AIRPORT LAND USE COMMISSION RIVERSIDE COUNTY AGENDA

STAFF REPORT

CASE NUMBER: ZAP1011BL16 – NRG Energy (NRG Renew DG Holdings, LLC) (Representative: James Kelly)

JURISDICTION CASE NO: CUP03728 (Conditional Use Permit No. 3728)

Figure 1
Blythe II Solar Project
Project Location Relative to Blythe Airport Runways

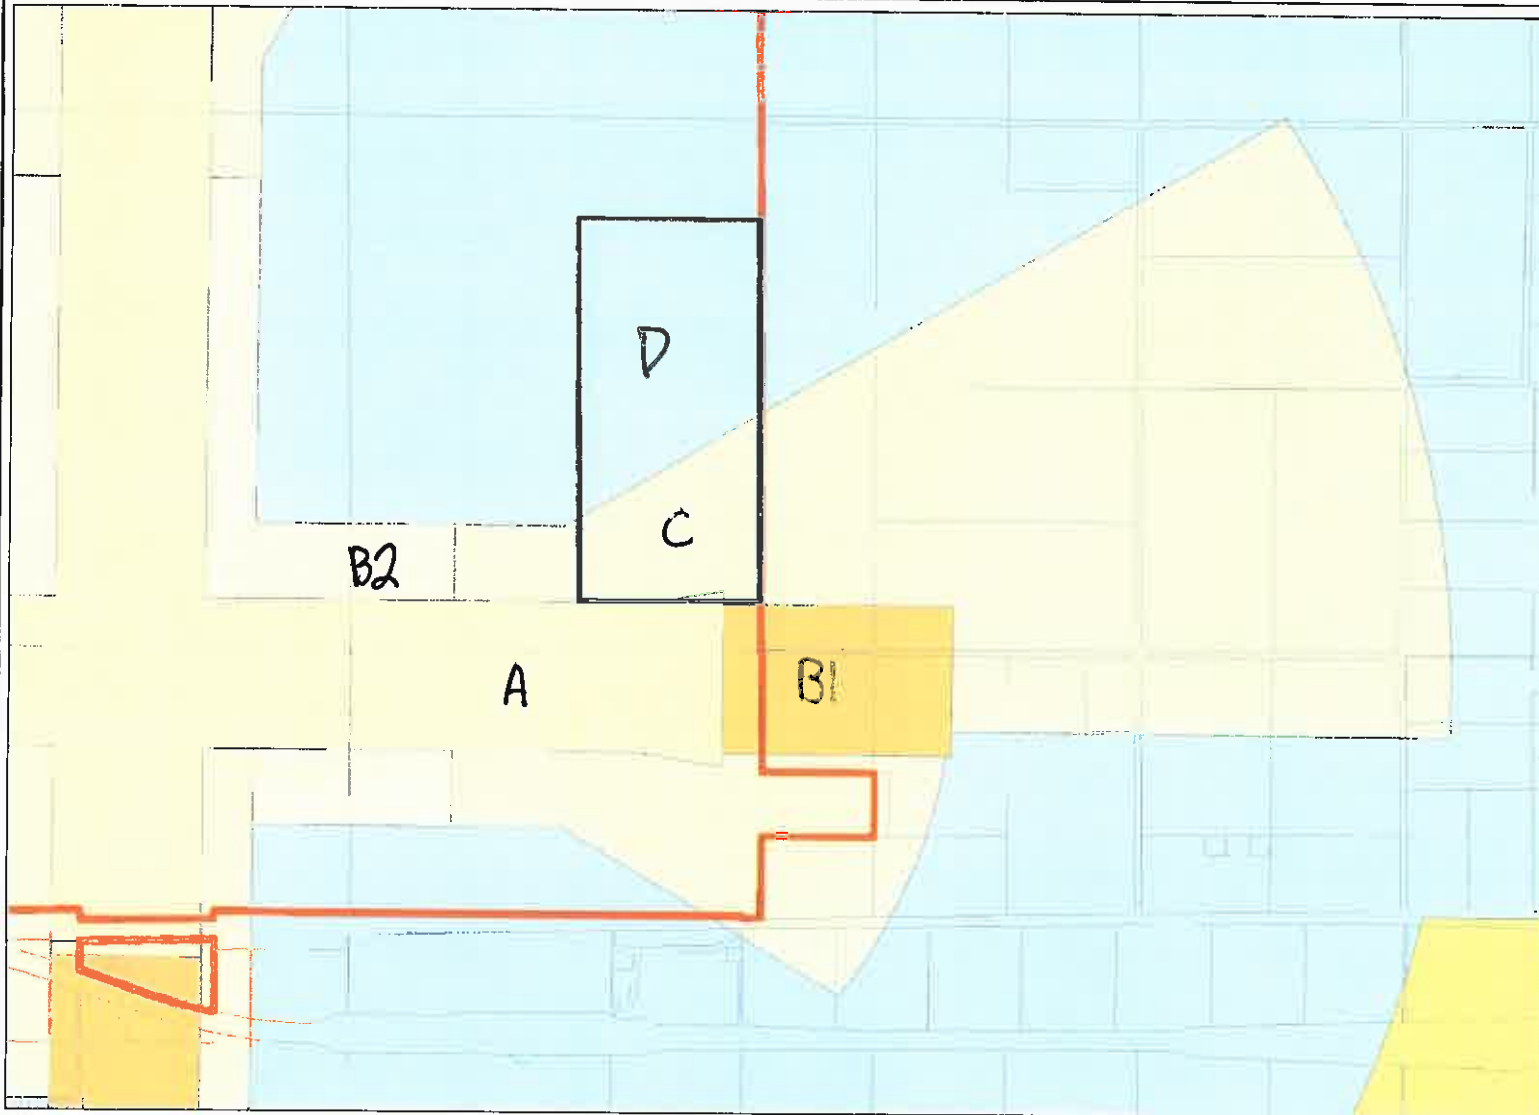
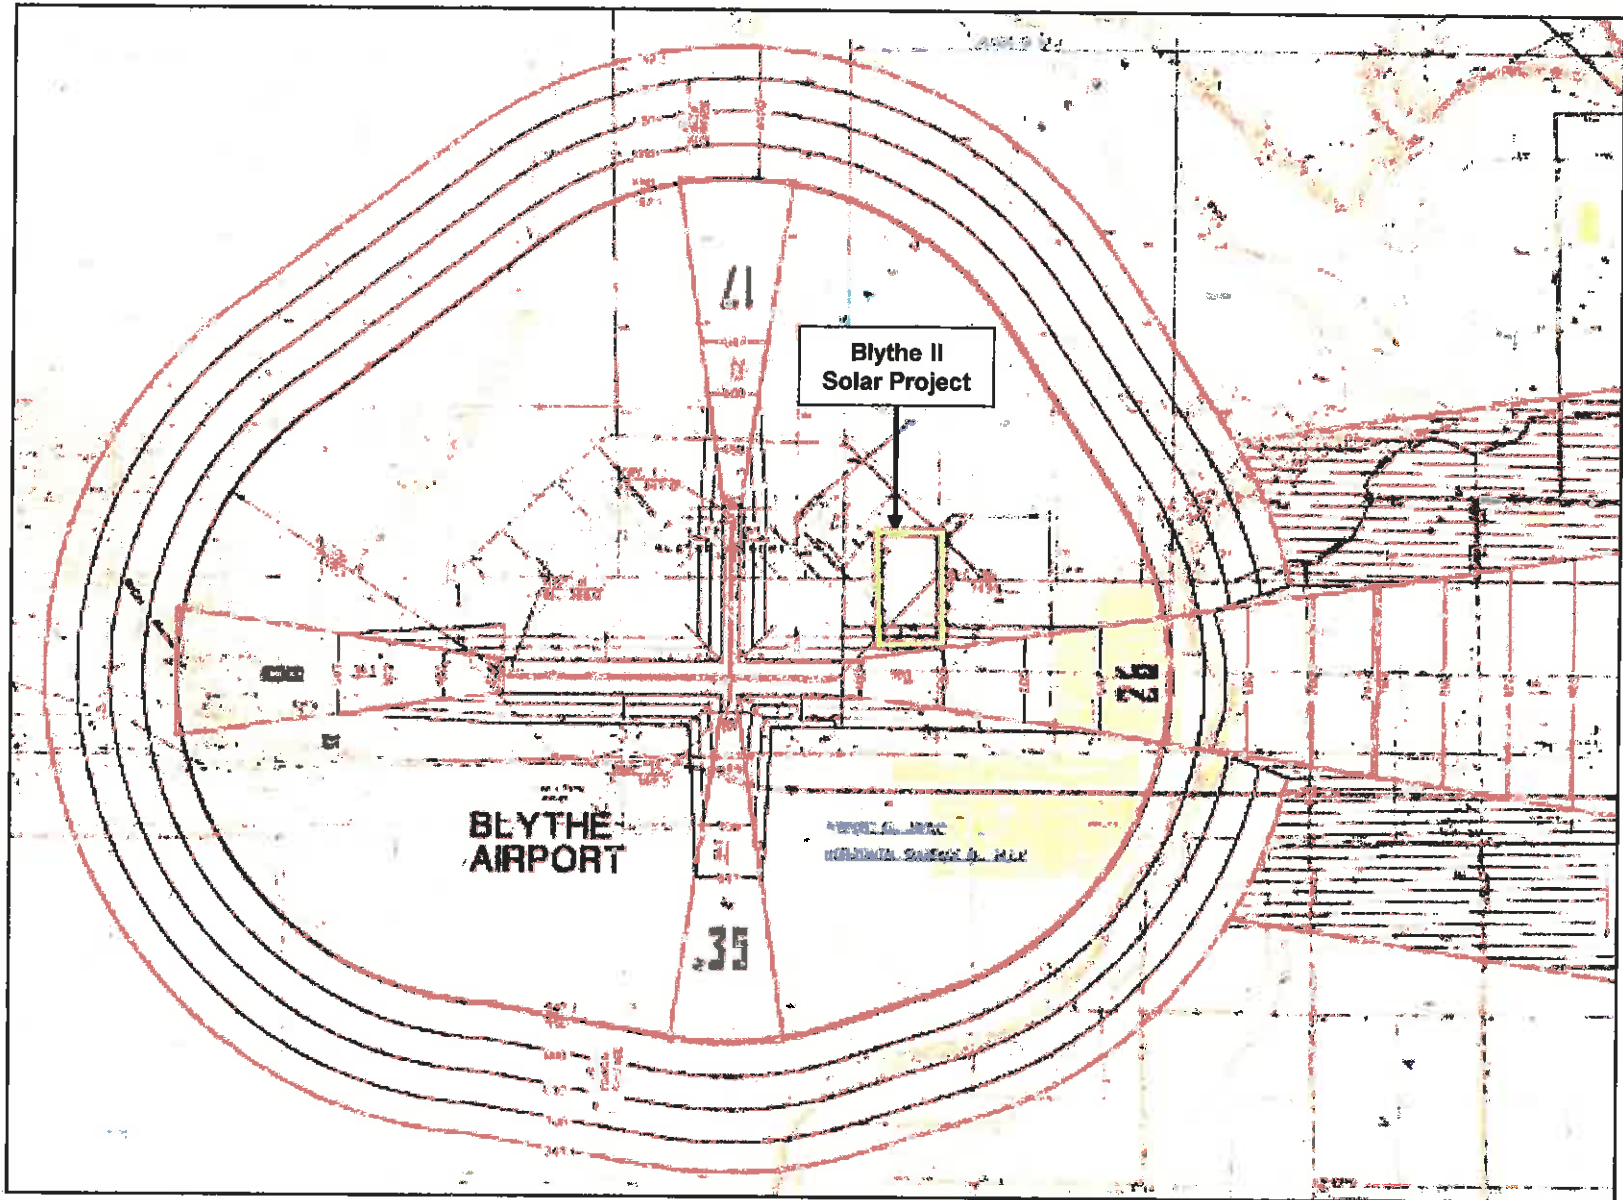
The Blythe II Solar Project is a proposed 20 MW photovoltaic (PV) solar project proposed to be located on approximately 156 acres of land at the Blythe Airport (BLH) near Blythe, California. **Figure 1** shows the location of the proposed solar project in relation to the airport and runways.

Figure 3
Blythe II Solar Project
Proposed Site Layout

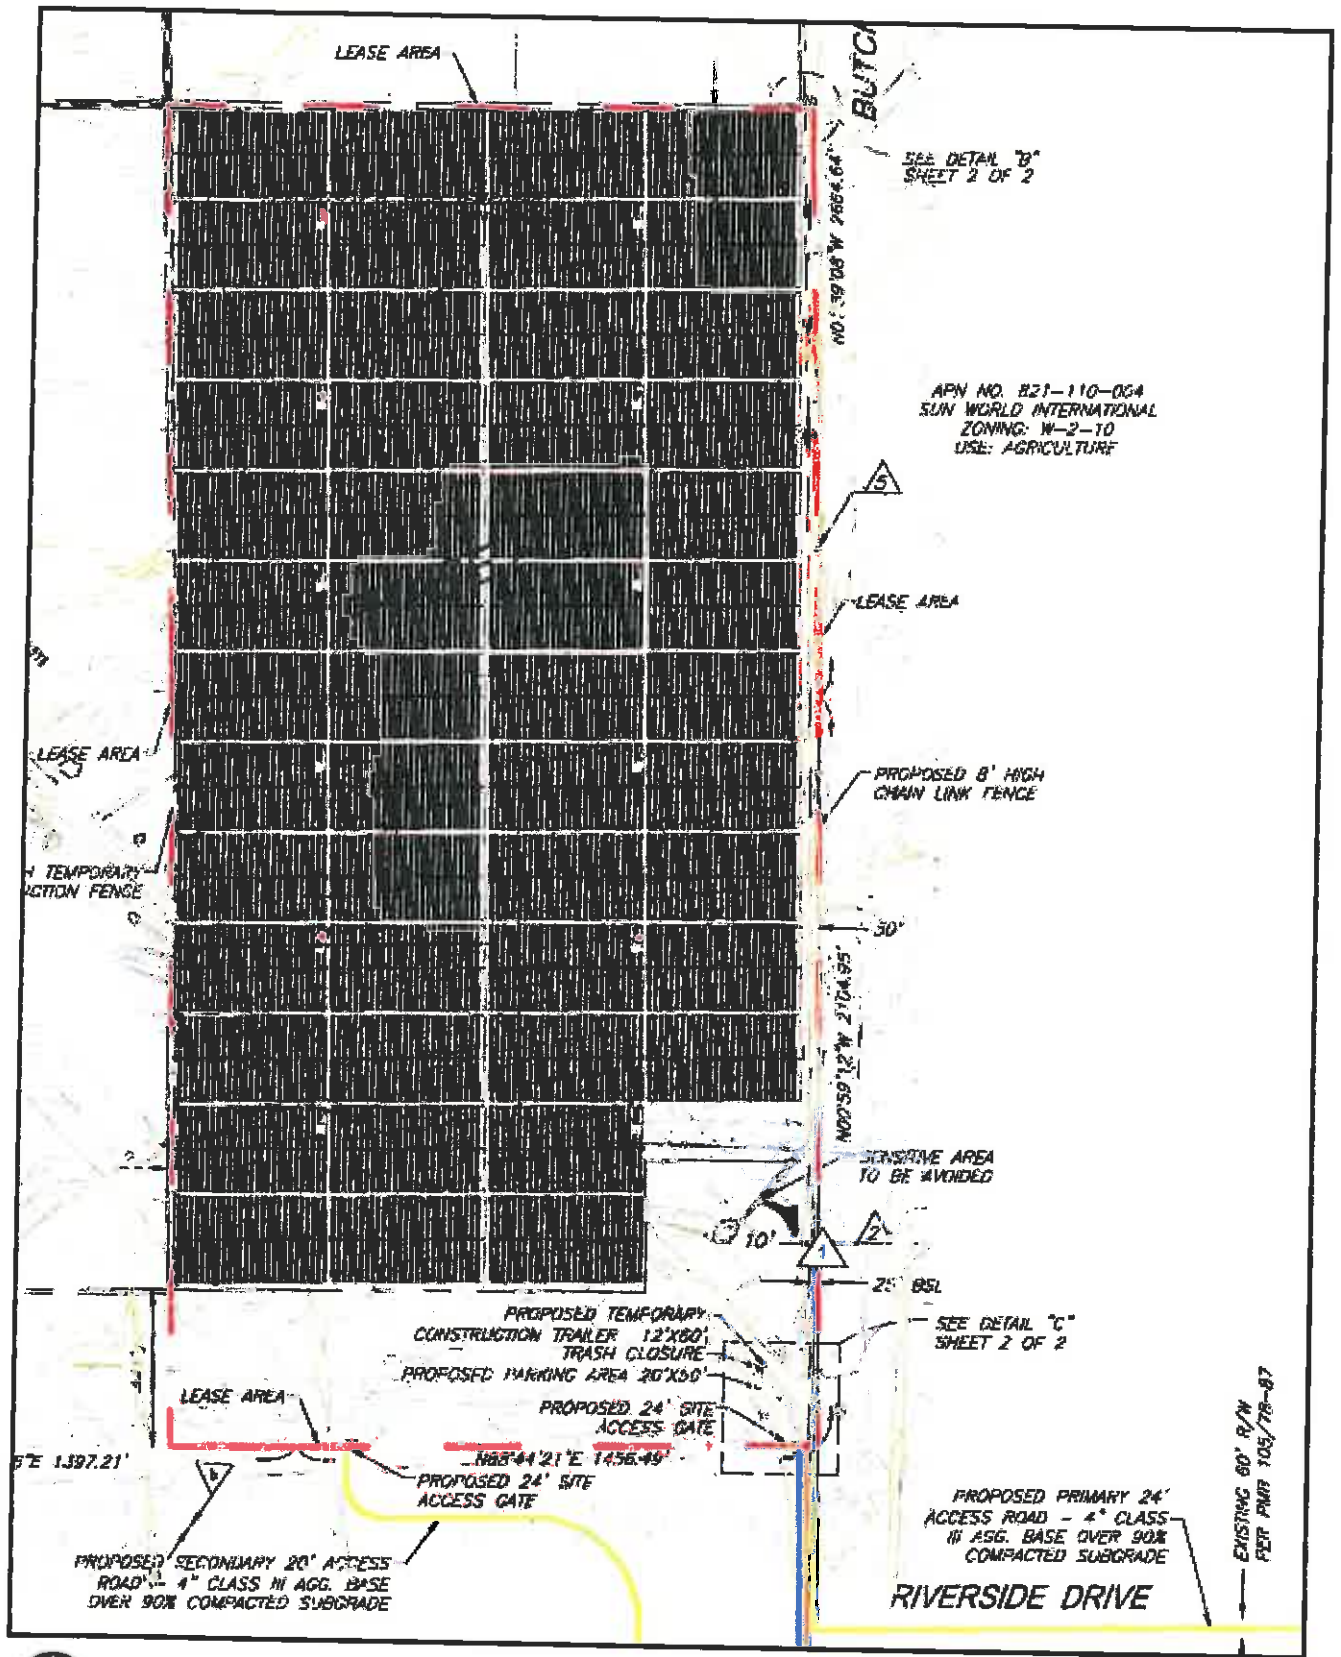
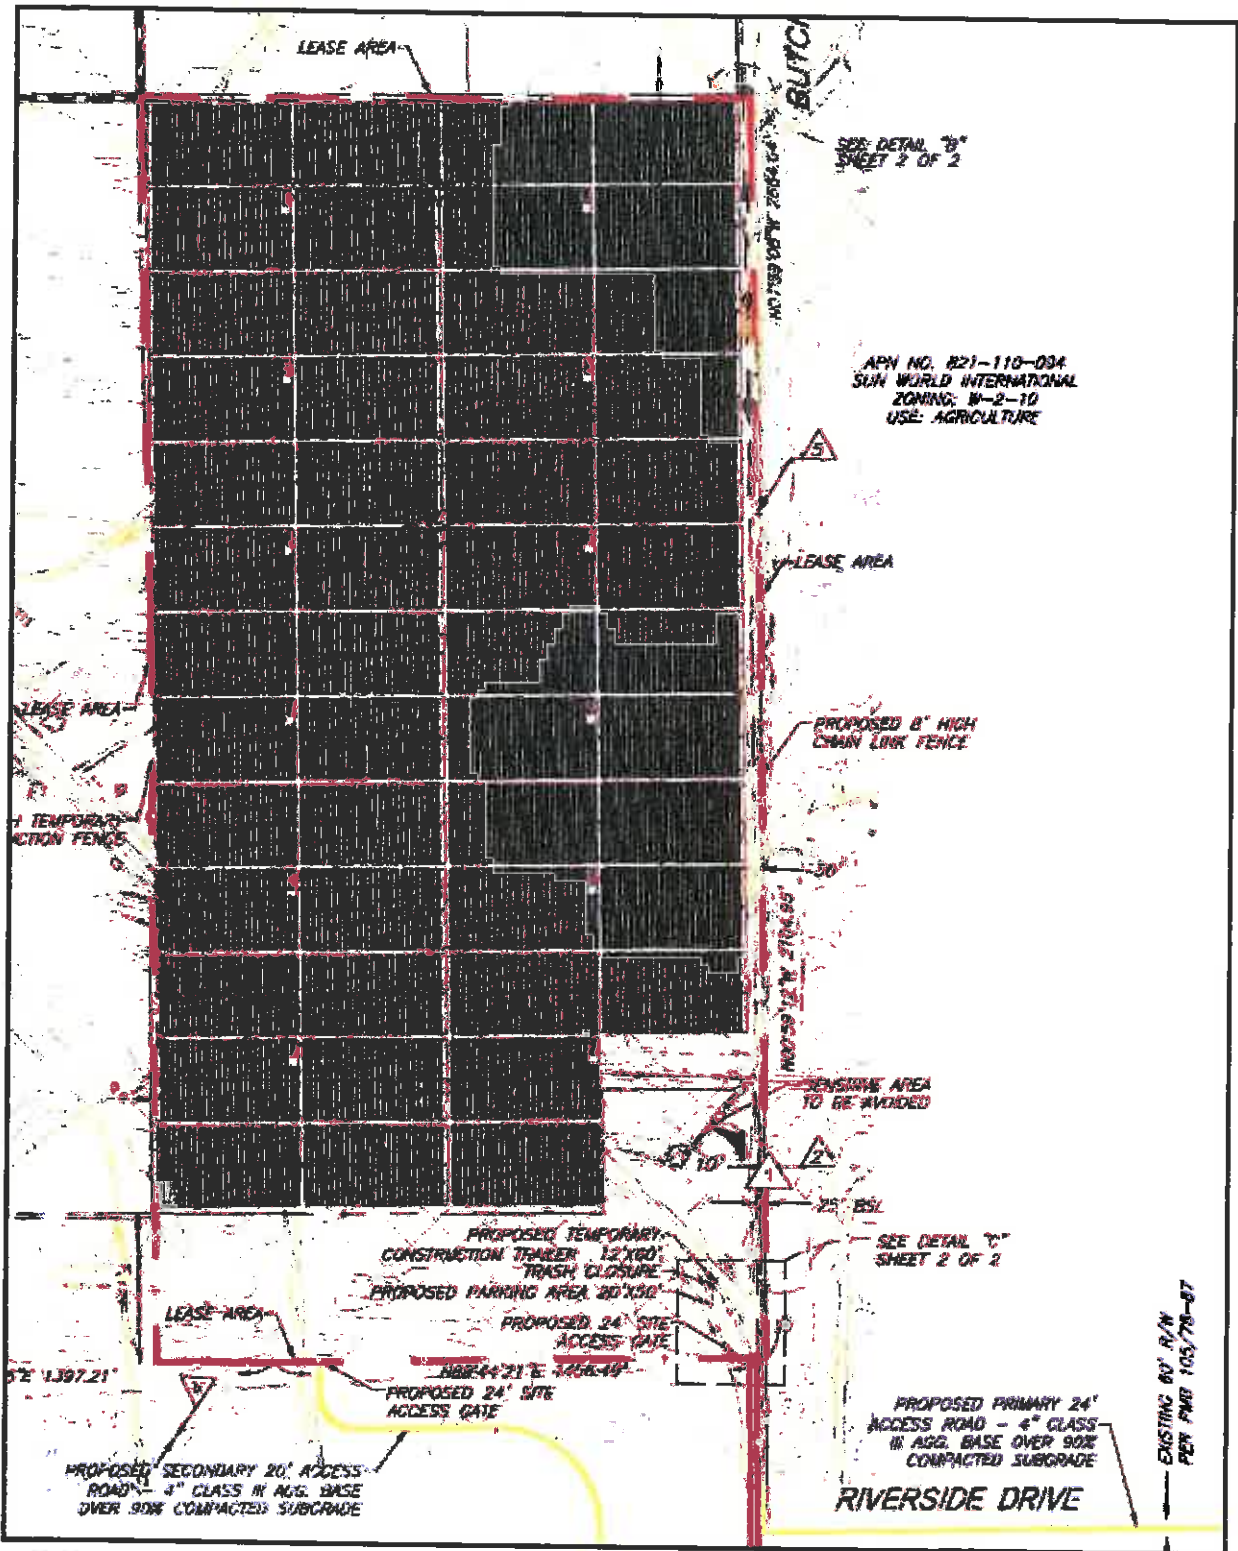
- The site layout plan for the Blythe II Solar Project (**Figure 3**) that includes PV panels with anti-reflective coating (ARC) and a single-axis tracking panel mounting system
- The six (6) outlying corners of the panel array were used to identify the geoposition of the project
- Four (4) points to identify each of the four (4) flight paths originating at the runway threshold paint bar at the end of each runway
